Montrose Report

Engagement Summary

April 2021

Thank you for helping to shape the Montrose intersection upgrade

Artist impression of the new Montrose intersection design

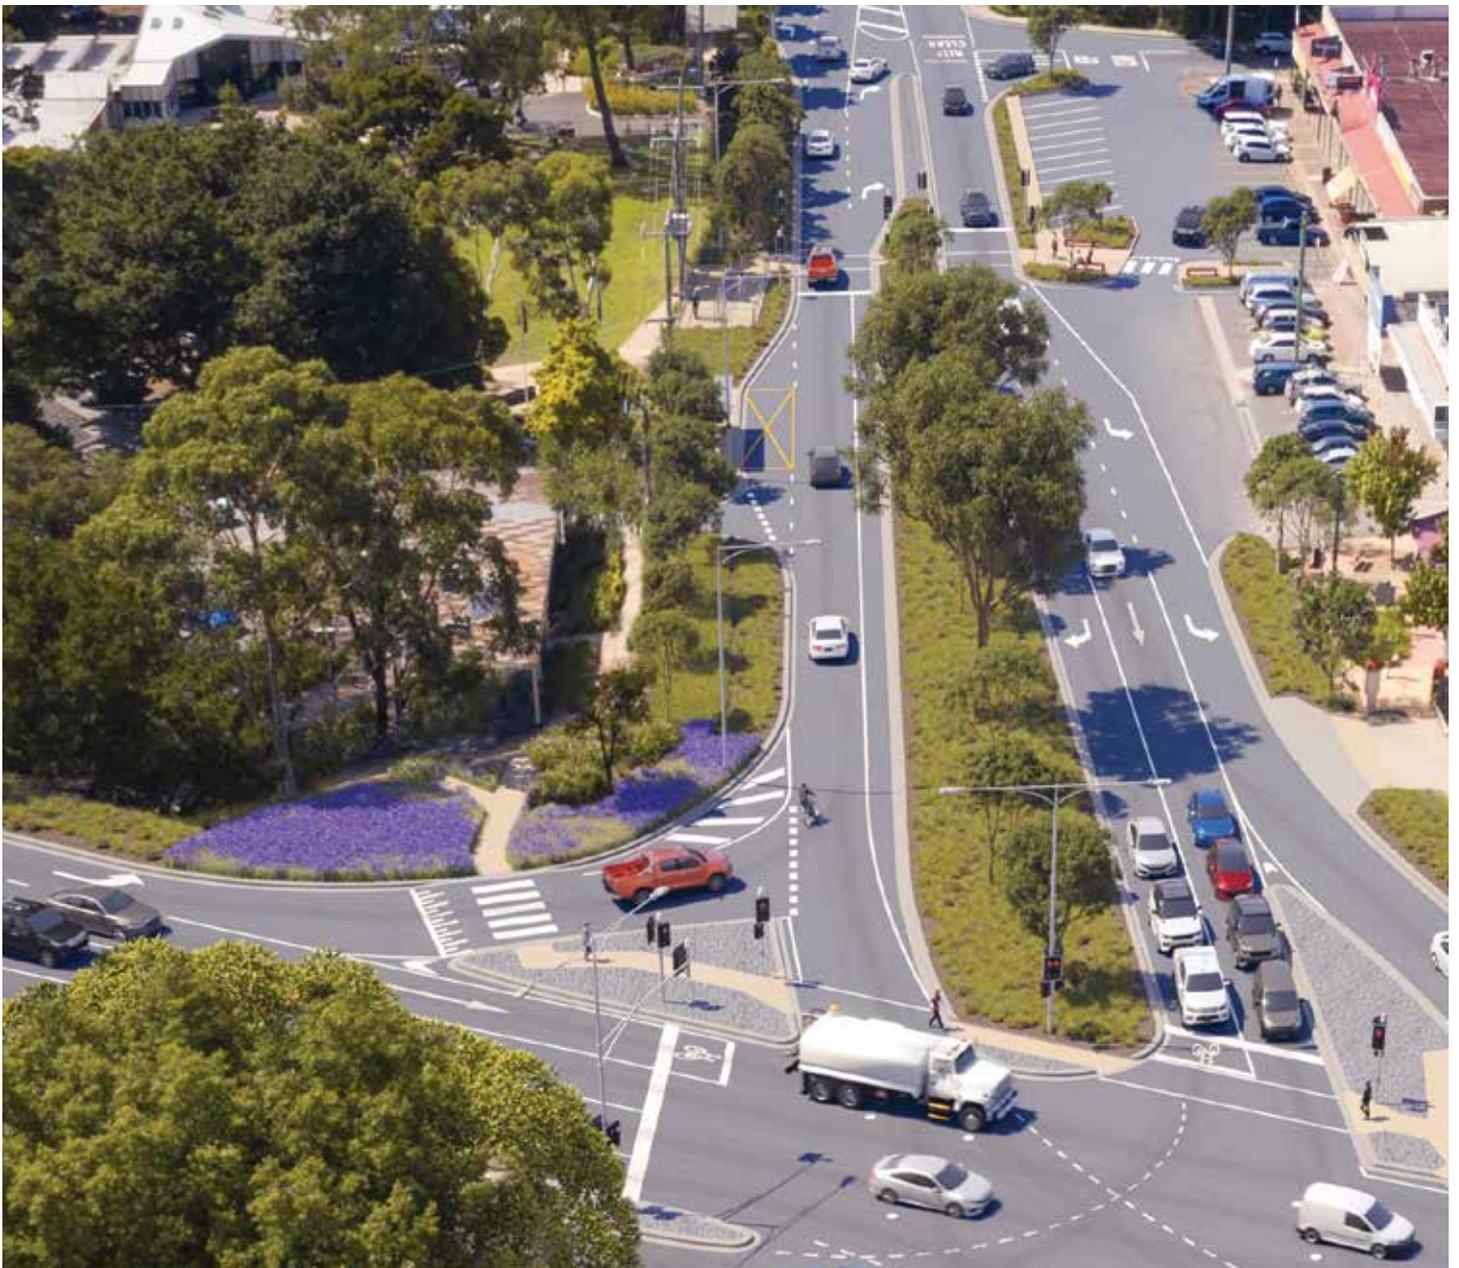
"(The) safety of pedestrians and road users should be the number one priority."

"The pedestrian crossing on Leith Road is an important part of the project that needs to be looked at from a safety and traffic flow perspective."

"Traffic signals (need)...to be sequenced appropriately to allow for the smooth flow of traffic."

"The new design fits in more appropriately with the character and fit of Montrose than the previous design."

"With the changes to Tourist Road, more cars will be making a U-turn at the intersection when leaving the shops to head back to the Dandenongs."

"Safe and reliable access to the Montrose CFA station (is important)."

"A safer speed limit when travelling through Montrose needs to be investigated."

Since 2017, community feedback has helped influence the design to better suit the needs of the community. What we heard during our latest consultation will help us to deliver an effective intersection upgrade, that will meet community needs for many years to come.

While we are not able to accommodate every suggestion or comment provided by community members, we're working hard to find a balance that addresses as many of these issues as possible.
